81130A-05

S E R V I C E   N O T E

81130A Pulse Generator: 81132A Channel Add/Repair

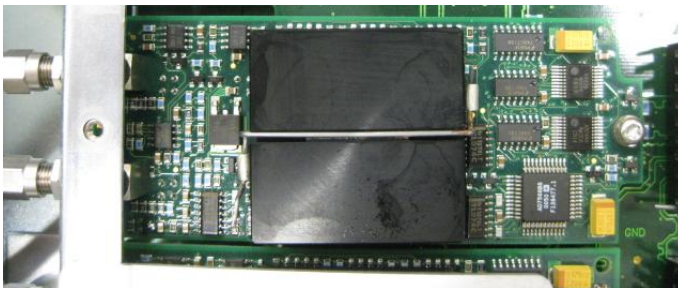
There are now 2 types of 81132A channel modules for the 81130A. They differ in specification, part number and appearance.

Old channel module:

81132-69509	660MHz Output Channel Board Pulse Generator EXCH
81132-69509-DEF	660MHz Output Channel Board Pulse Generator Return

New channel module:

81132-60510	660MHz Output Channel Board Pulse Generator Spare
81132-69510	660MHz Output Channel Board Pulse Generator EXCH
81132-69510-DEF	660MHz Output Channel Board Pulse Generator Return

- When you **upgrade** a 1 channel unit to a 2 channel you have to upgrade using the type of channel that is already used in the box, i.e. older type units (81132-66509 channel) must be upgraded with older type channels 81132-69509 and newer type channel units (81132-60510) must be upgraded with newer type channels (81132-60510).

- When you **repair** a unit, please order and use the type of channel that is already used in the 81130A box.
  Do not change or mix the type of channel.
  Older type channel modules must be repaired with older type channel modules (channels) and new type modules with new.
  It is not possible to mix the modules!
